# **Staff Report**

Re: PLNSUB2016-00835 West Gateway Commons Planned Development

## **Planned Development**

23 5Q. FT. 53 5Q. FT. 1 5Q.FT.	SOUTH ELEVATION F TOTAL AREA OF SO GLAZING: STUCCO: PERCENTAGE OF ST	UTH ELEVATION	
07 5Q. FT. 7 5Q. FT. 5Q.FT.	NORTH ELEVATION FI TOTAL AREA OF NOR GLAZING: STUCCO: PERCENTAGE OF STU	RTH ELEVATION

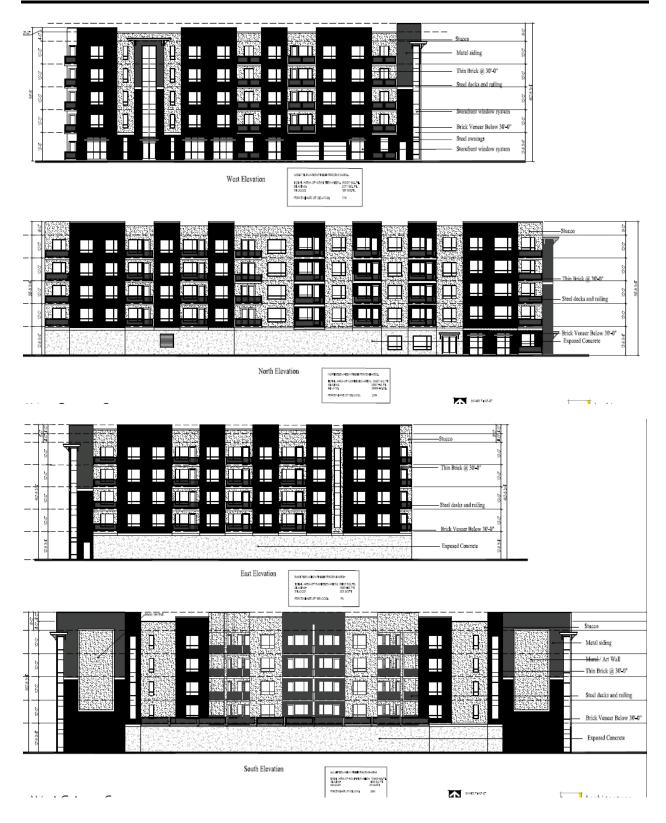
The GMU zoning district requires that all buildings have at least 70% of the facade, excluding windows, constructed of the following materials: brick, masonry, textured or patterned concrete and/or cut stone. The only other exterior material proposed for this building is stucco which represents less than 30% of the façade and is generally used in recessed portions of the building (actual percentages are listed on the elevations). Other materials are allowed through the Conditional Building and Site Design process, however since the building meets the code requirements, it complies with the base zoning.

materials	70% of materials are to be brick masonry textured or patterned concrete or cut stone	Complies: Stucco is proposed for indented portions of the façade, which account for less than 30%.
